In re Patent Application of	)	
	)	
Peter A. MILLER	)	Group Art Unit: 2827
	)	
Application No.: 09/839,151	)	Examiner: Ishwarbhai B. Patel
	)	
Filed: April 23, 2001	)	Confirmation No.: 1629
	)	
For: UHF GROUND INTERCONNECTS	)

**REQUEST FOR APPROVAL OF DRAWING CHANGES**

FIGURE 1

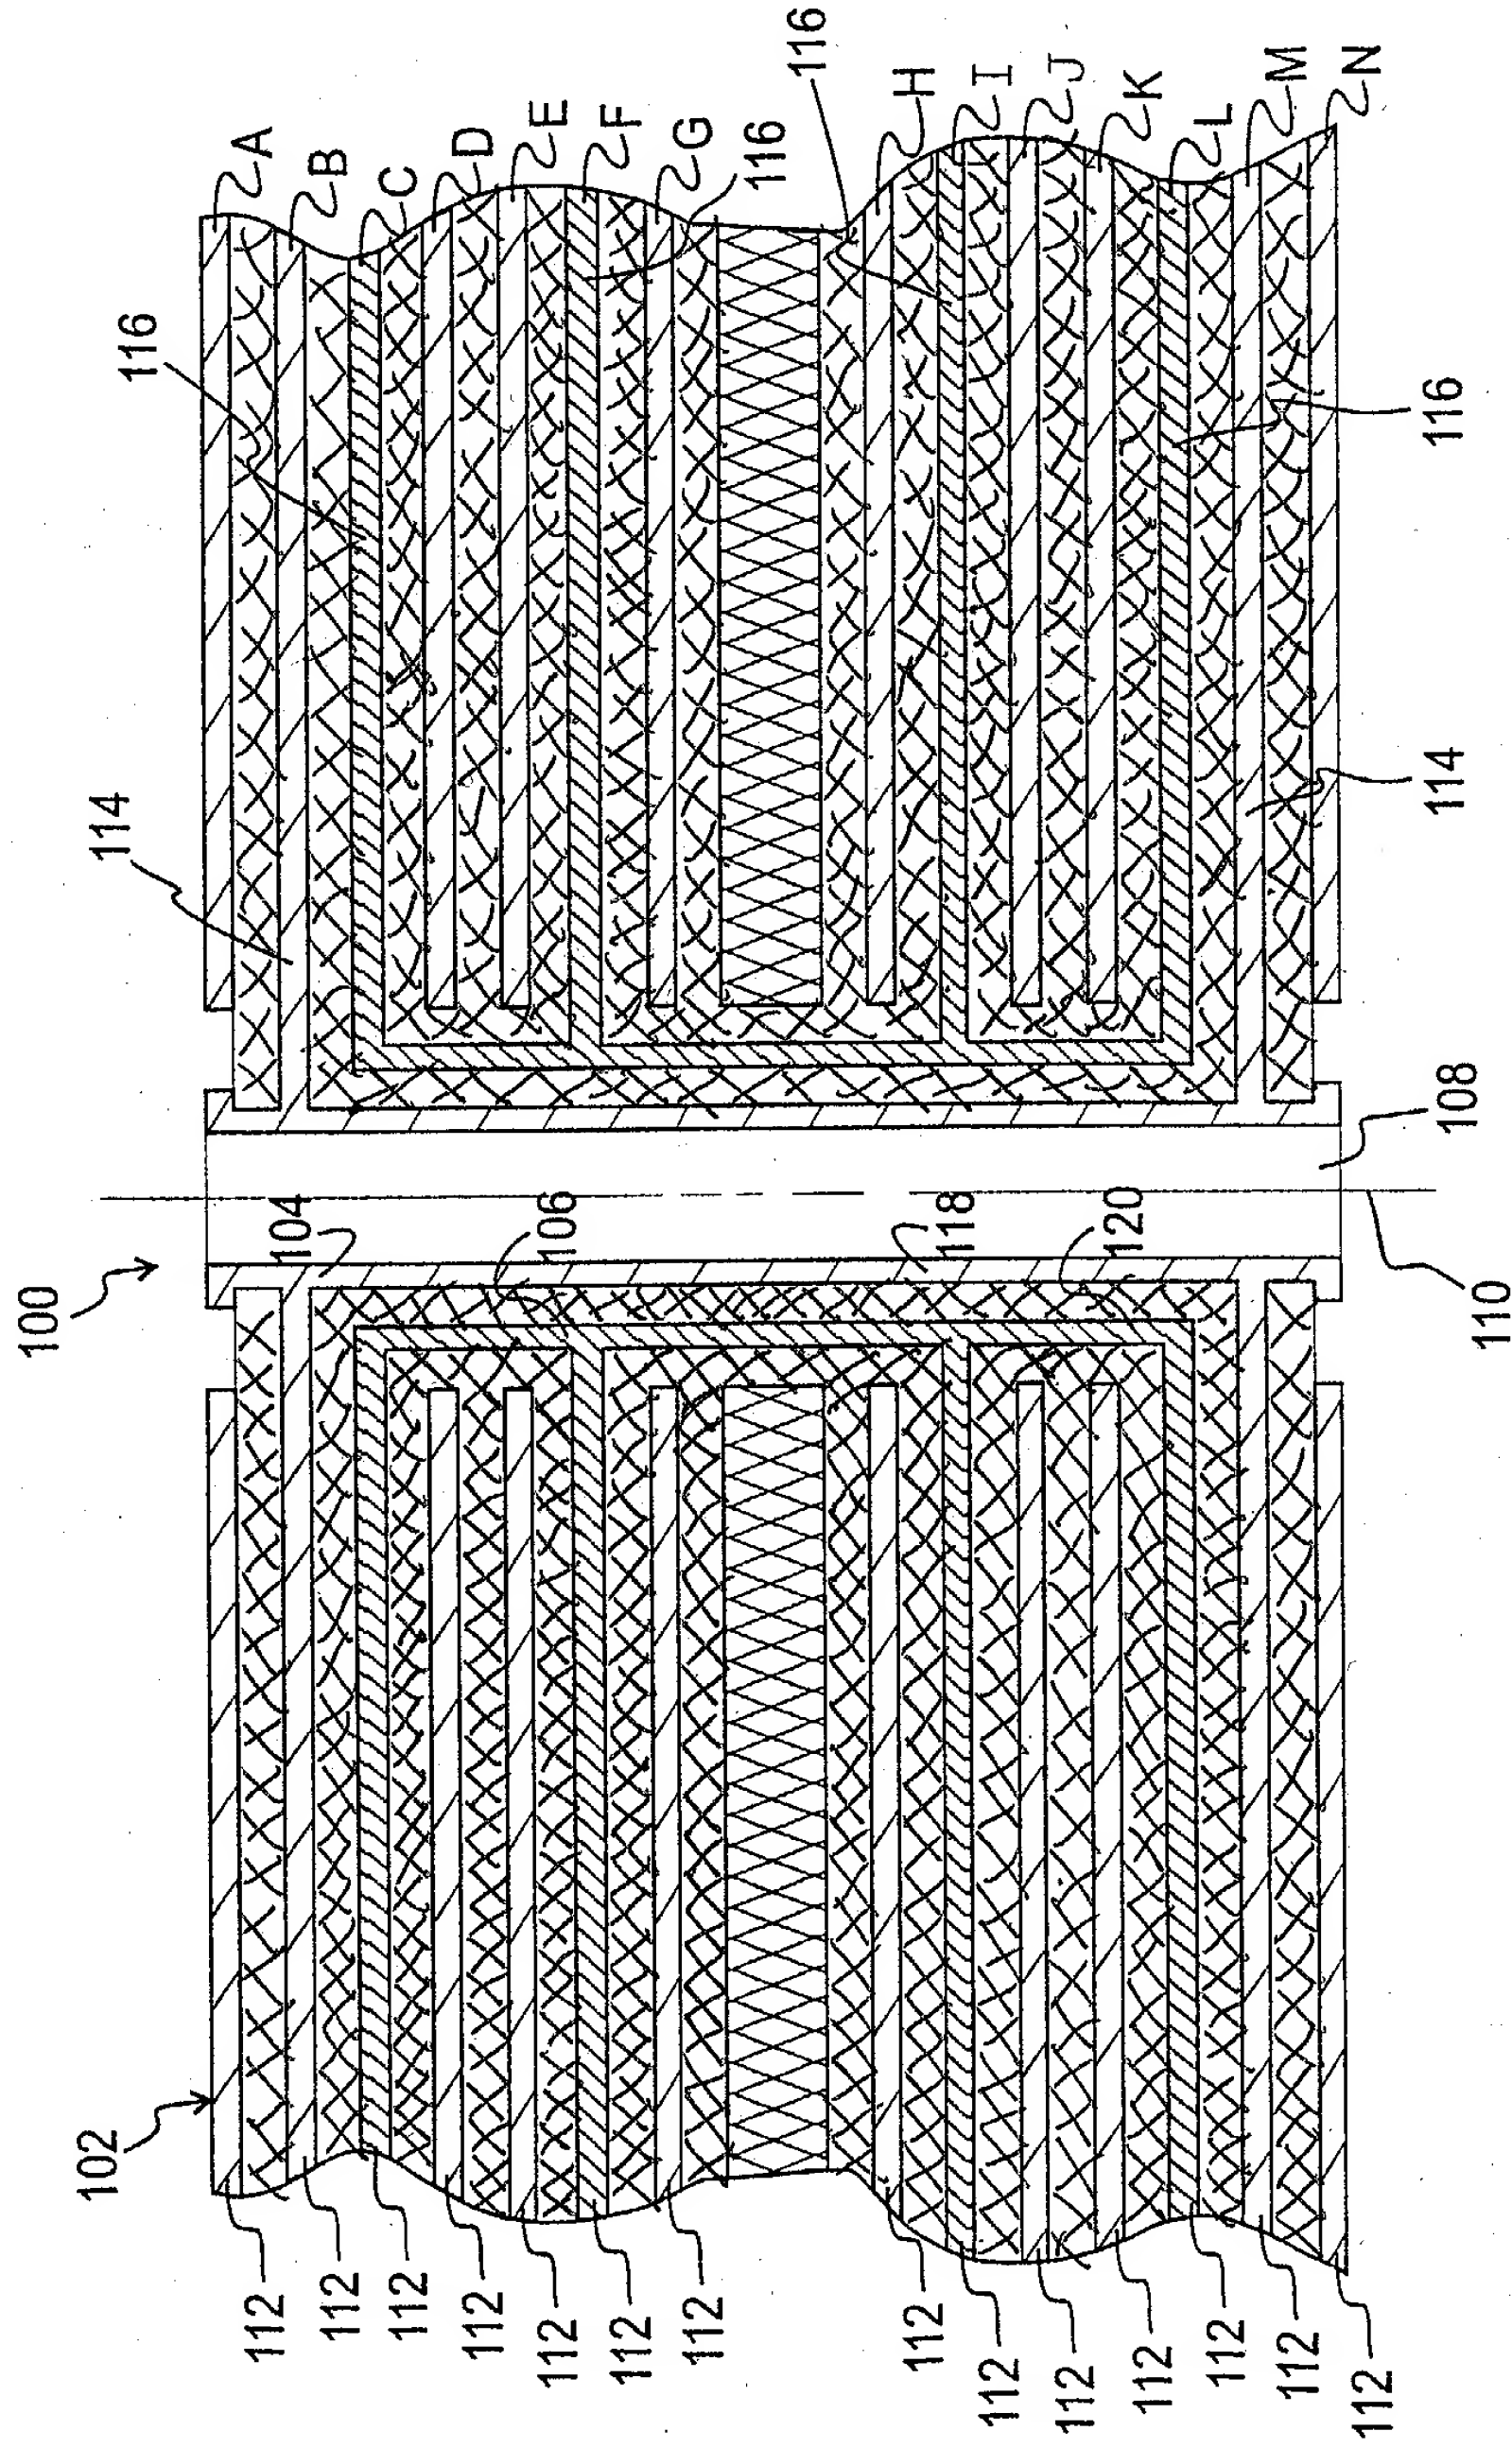
The Examiner's approval is respectfully requested for the proposed changes. Figure 1 has been changed by indicating in crosshatching all the parts that are shown in section. The addition indicates that the layers between the layers 112 are dielectric material.
